S/UNI-ATLAS DATASHEET ERRATA

PM7324

DATA SHEET ERRATA

ISSUE 10: MARCH 2001

NOTE: Segment and End-to-End F4 Must be Set Up as a Single Connection

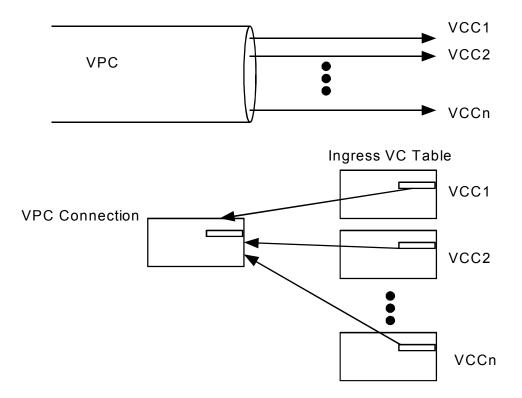
In some applications, segment and end-to-end F4 OAM connections are configured as two separate connections. This should not be done, as it will cause one additional read to Row 2 of the second F4 OAM connection per cell access, thereby increasing the maximum processing cycle by 1.

In the case where the additional F4 OAM connection is in AIS or CC alarm, or if the background process has just decremented its CC alarm counters (which occurs once per half second), an additional write to Row 2 of that OAM connection may also occur. It is possible that this additional write could coincide with a write to the first F4 OAM connection.

Instead, a single connection should be used for both Segment and End-To-End F4 OAM, and cells from both VCI= 0003 and VCI = 0004 should resolve to this connection. This combined OAM connection handles both the End-to-End and Segment OAM simultaneously in much the same way that any other connection does. This avoids the additional read or write operations to Row 2 of the second F4 OAM connection. This is shown in the figure below
